REMARKS

Specification and Drawings

The specification and drawings are amended in response to the various objections raised in paragraphs 1 and 2 of the Office Action. Revised drawings sheets and annotated marked-up drawing sheets are submitted under an appended paper.

Annotated Marked-Up Drawing

Figure 1

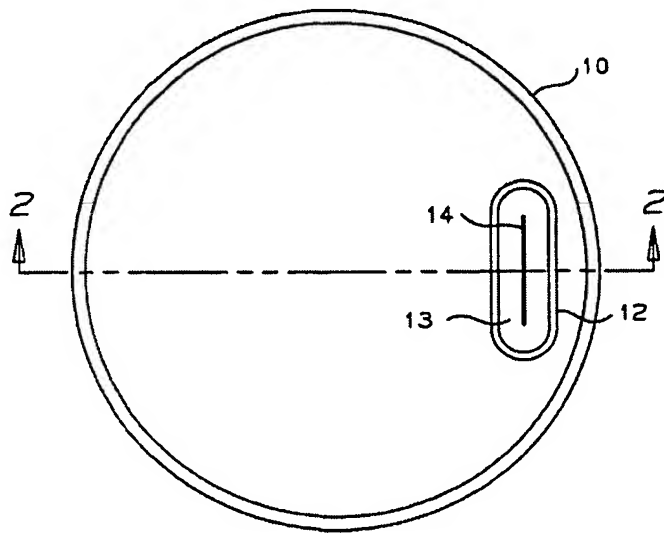
Freeman teaches a beverage container 11 having a cap (closure) 10 including a spout 12, and a thin membrane 13 mounted attached to spout 12. The membrane 13 includes a slit 14 to that opens during use to facilitate fluid flow:

Freeman clearly teaches (see Col. 2, lines 48-52, reproduced below for reference) that the slit 14 is formed either by molding the slit into the membrane, or cutting the membrane using a sharp edged object:

After the closure 10 is manufactured to the form shown in FIG. 4, the thin membrane 13 is assembled or
50 insert molded into the spout 12. The slit 14 is either molded into the thin membrane 13 or is formed with a sharp edge after the thin membrane 13 is produced.

Figure 6

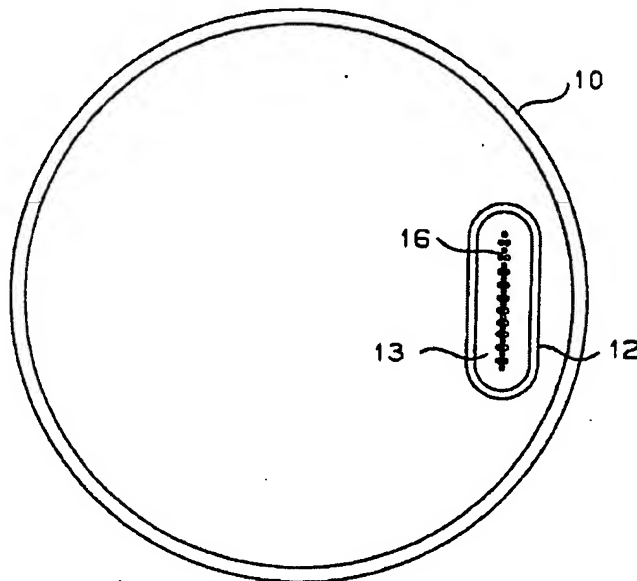
Freeman also teaches an alternative embodiment (see Freeman's Fig. 6 and associated text from Freeman's Col. 2, which are reproduced below for reference) that utilizes a line of puncture

holes 16 to form an elongated slit-like opening in the membrane 13 that operates in a manner similar to the slit 14 used in the other embodiments disclosed by Freeman:

40 Another alternative for similar purposes is specifically shown in FIG. 6 wherein the thin membrane 13 does not contain slit 14, but rather a plurality of punctured holes 16. In all other respects the closure 10 functions as disclosed in FIGS. 1 through 5 and in the written description pertaining thereto.
45

Those skilled in the art will recognize from the above disclosure that Fig. 6 shows a membrane having a slit-like opening formed by an alternative production method (i.e., different from the molding or cutting method used to form slit 14). That is, by forming a line of closely-spaced puncture holes 16 in the thin membrane 13, the material located between the adjacent puncture holes 16 tears or splits, thereby forming a fissure that extends along the entire line of holes 16. Alternatively, even if this fissure is not immediately created during the puncturing process, the fissure would be created the first time the cup was used (i.e., the applied pressure would cause the relatively weak sections between the puncture holes to fail). In either case, the purpose of the Freeman's puncture holes 16 is not to pass fluid, but to form the elongated opening (fissure) that is clearly shown in Freeman's Fig. 6. Those skilled in the art will recognize that the purpose for forming the fissure using Freeman's puncture holes 16 (as opposed to forming a slit by molding/cutting the membrane) is that the two sides of the

split/torn portion of membrane material forms a tighter, more reliable seal than molded/cut slits.

FIG. 4(B)

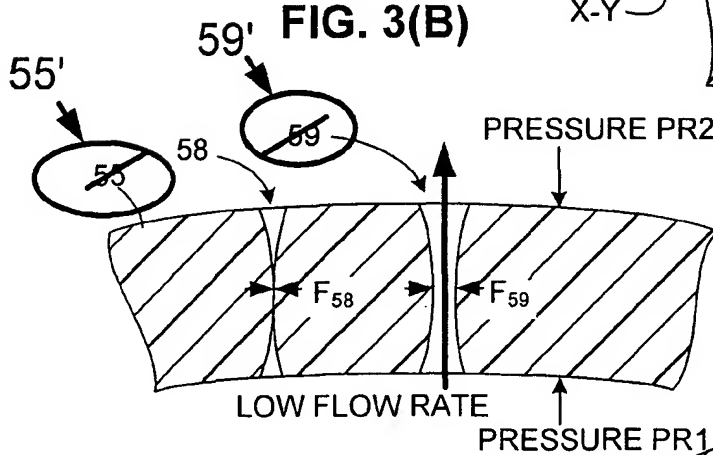
In response to paragraph 1a of the Office Action, Fig. 4(B) is amended to change "55" and "59" to "55'" and "59'".

FIG. 14

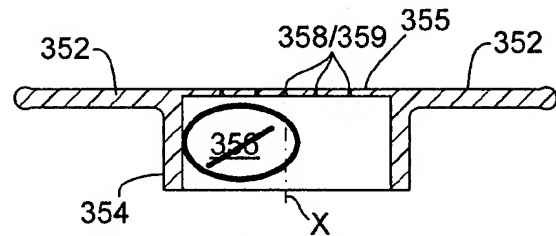
In response to paragraph 1a of the Office Action, Fig. 5 is amended to change "158'" and "159'" to "158" and "159", and Figs. 14 and 15 are amended to omit "356", "445", and "446".
